Tacoma Vision Zero Road Safety Audits

September 2024 ■ Year 1 Report

At the Intersection of S 54th St and S Tacoma Way

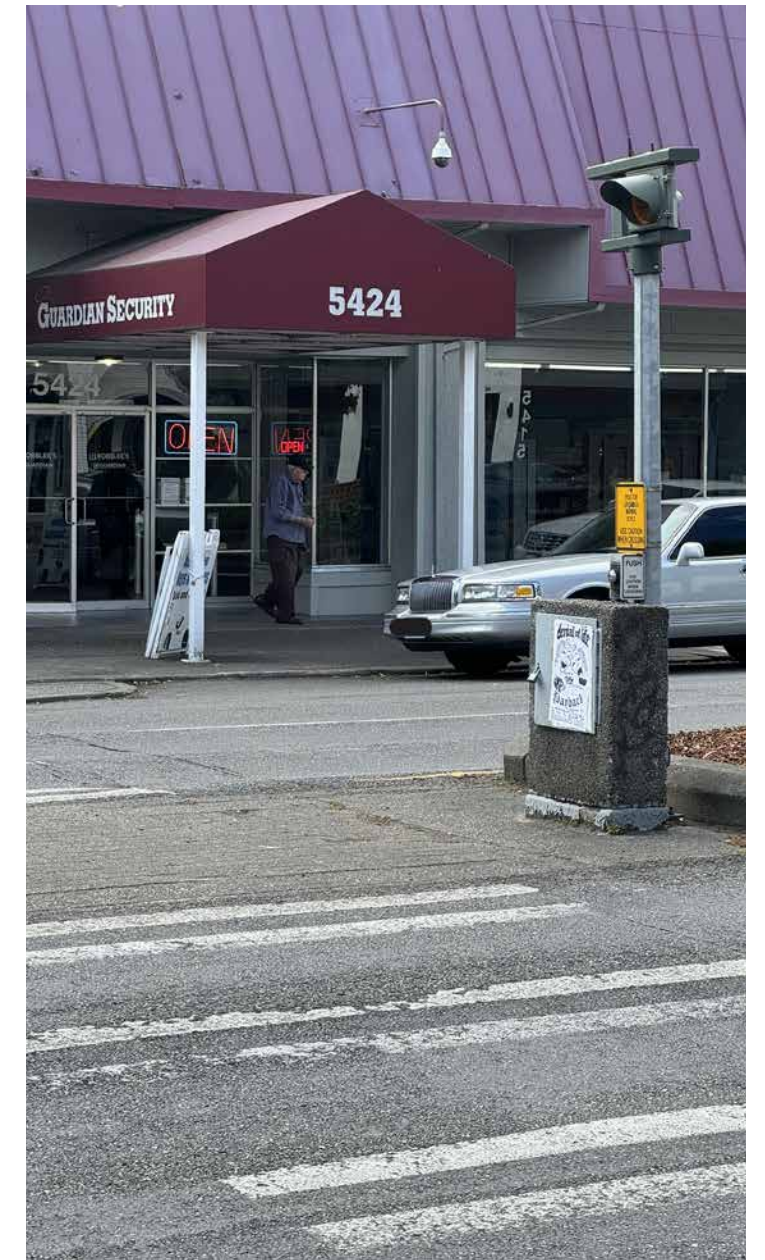
- There is limited lighting near intersection.
- Alighting from the back door bus is difficult and forces people into driveway area.
- There are substandard curb ramps here.
- South side of 54th St sidewalk needs repair.
- There is evidence of cars doing donuts in intersection.
- This is a good intersection for crashworthy art.
- Add temporary or quick build curb bulb outs that don't obstruct bicycle infrastructure.
- Add marked crosswalks.
- Add marked green bicycle crossings.
- Install 12" signal heads with backplates/reflectors.
- Look into Protected/Permitted left turns.

At the Intersection of S 60th St and S Tacoma Way

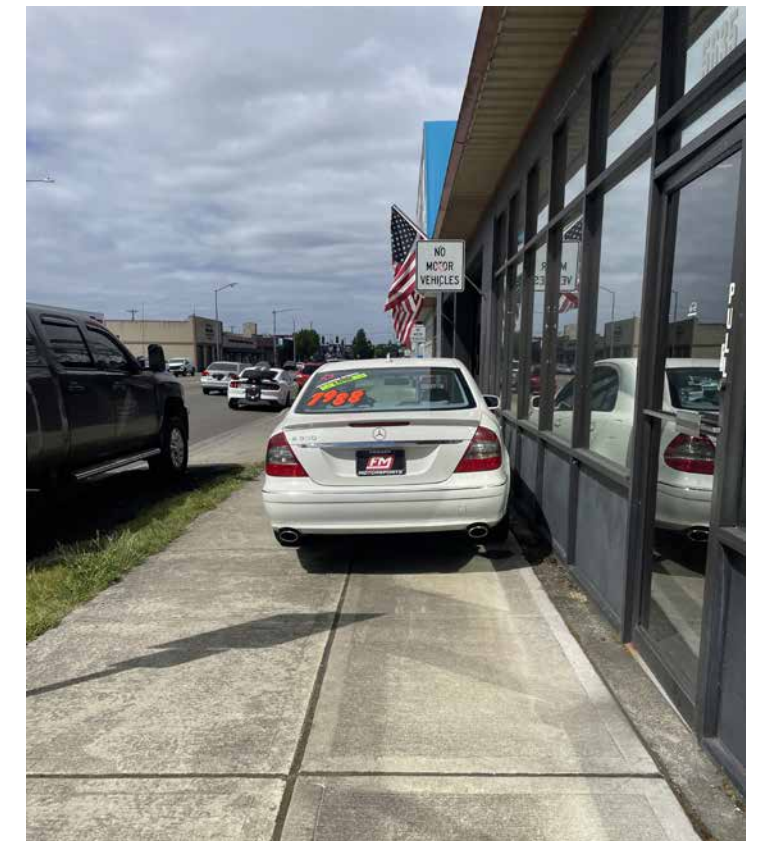
- There are no street signs at this intersection.
- The planned improvements for this intersection include bike infrastructure and marked crosswalks.
- Improve lighting at intersection.
- Add marked crosswalks.

At the intersection of South Yakima Ave and S 8th St

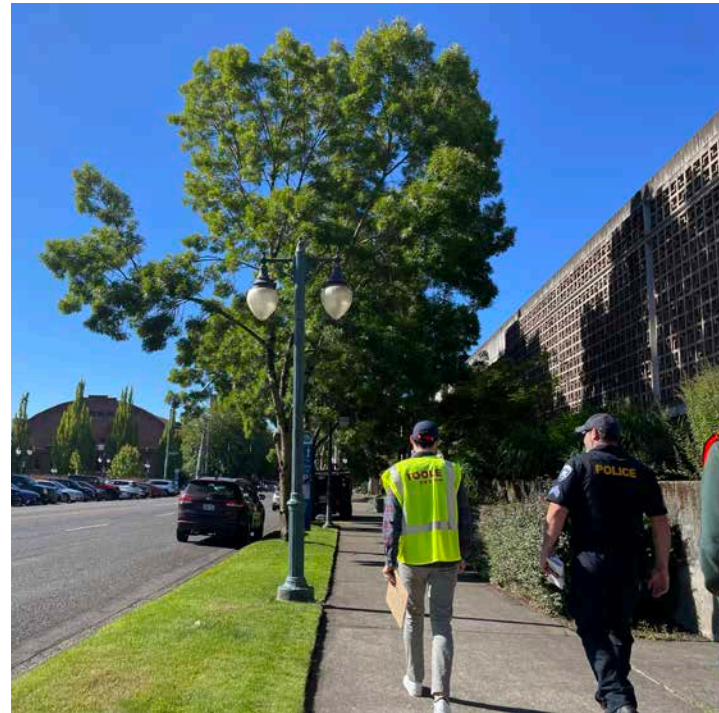
- Consider connections to 6th Ave bike lane.
- Ramps are compliant per inventory.
- Prevent parking close to intersection with curb extension.
- There are visibility issues north of intersection due to curve and posted speed at intersection.
- There is only one streetlight at the intersection.
- Consider/investigate possible pedestrian crossing enhancement. May need advanced warning.
- Envisioned bike boulevard but needs improved bike/pedestrian crossing.

At the intersection of South Yakima Ave and Earnest S Brazill St

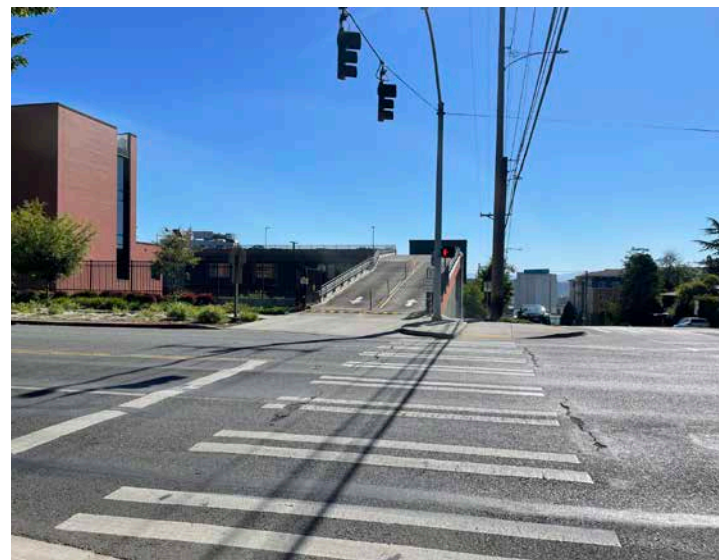
- Buses turning from Earnest to head south on Yakima can have issues when cars are parked too close to intersection on west side of Yakima.
- North side crossing was required as a part of the new building and replacement of the south was due to new sidewalk.
- Bates College did not update curb ramps on southwest side. ADA ramps not compliant on west side for N/S and the receiving ramp on the south.
- To address all signal comments, signal system would need to be completely reconstructed.

Along South Yakima Ave between S 19th St and S 21st St

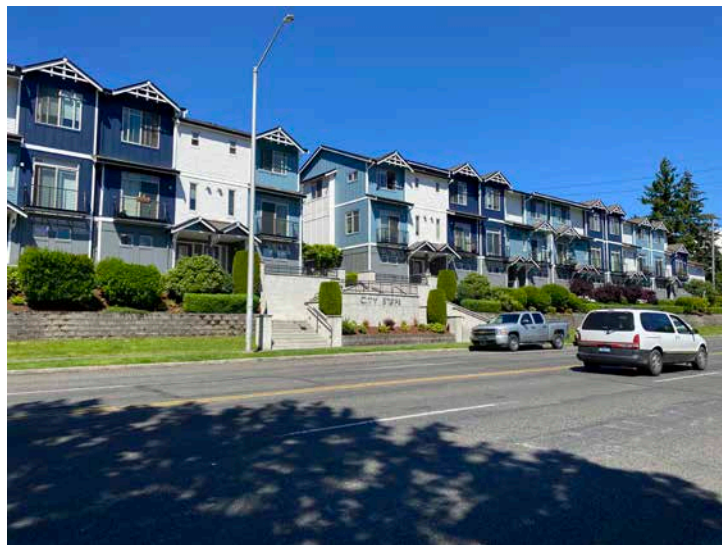
- No sidewalk buffer on east side.
- Pre-app c. 2022 for large multi-family development. No permits.
- Pre-app c. 2023 for large affordable senior housing. No permits.
- Planned redevelopment to include 7' sidewalks.
- Close unused driveways and add new landscaping for better aesthetics and also prevents unintended uses.

At the intersection of S Pine St and S 36th St

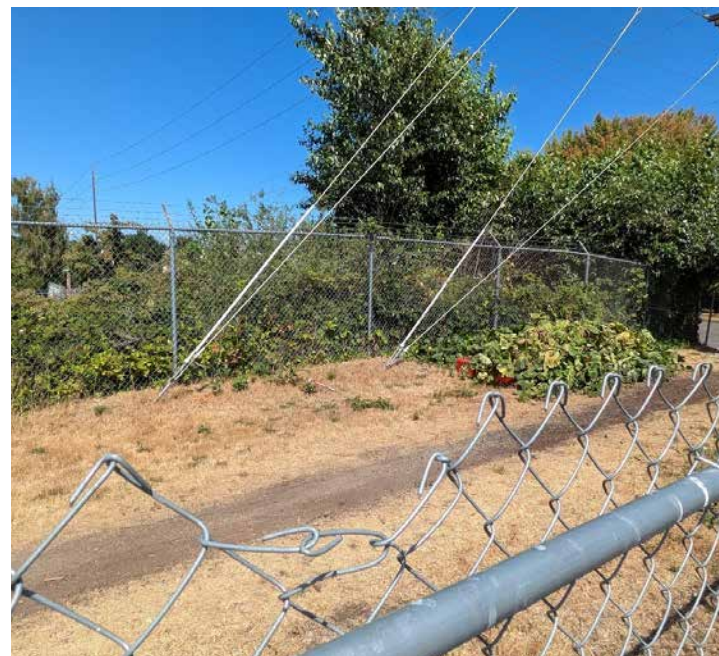
- 12/8/8 signal heads E/W.
- 12/12/12 signal heads N/S.
- No video detection.
- No APS.
- No pedestrian ramps.
- No crosswalk markings.

Existing APS and video detection. At the intersection of S Pine St and S 45th St

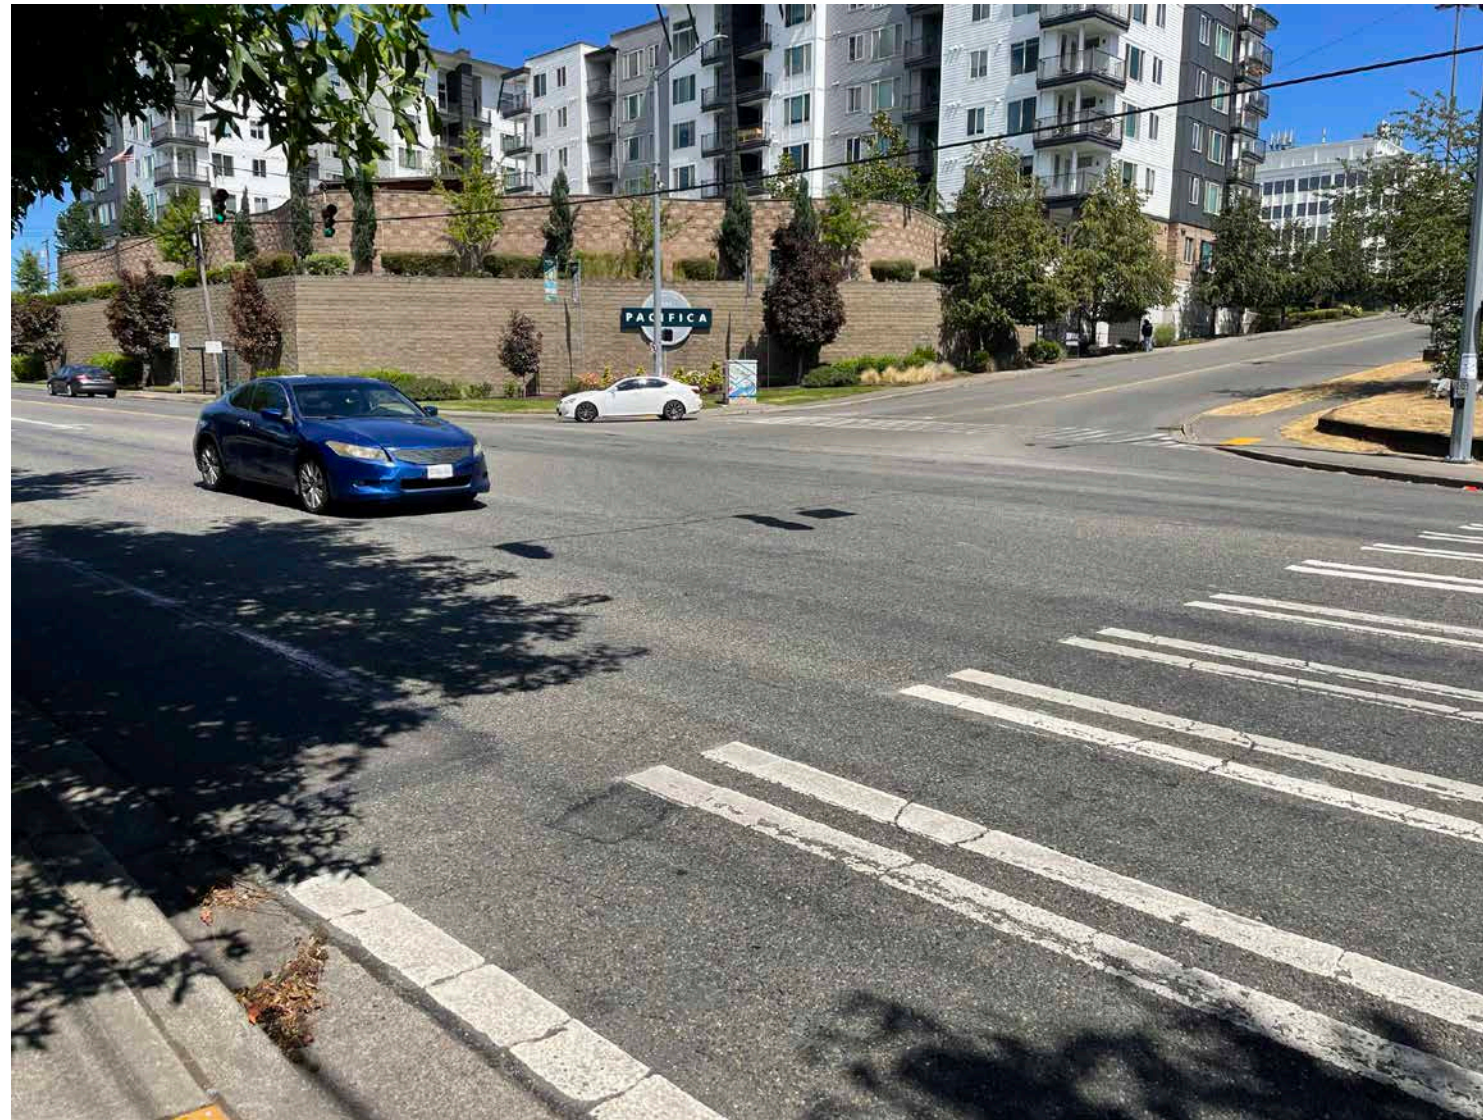
- Median with potential sculptural element, archway across path, etc -- many creative options here!
- S 45th St is part of Loop road from Tacoma Mall Subarea Plan.
- Look at making S 45th St right-out only.
- Recently installed daylighting on S 45th St.
- Community member's service animal was struck at S 45th St when driver did not stop.
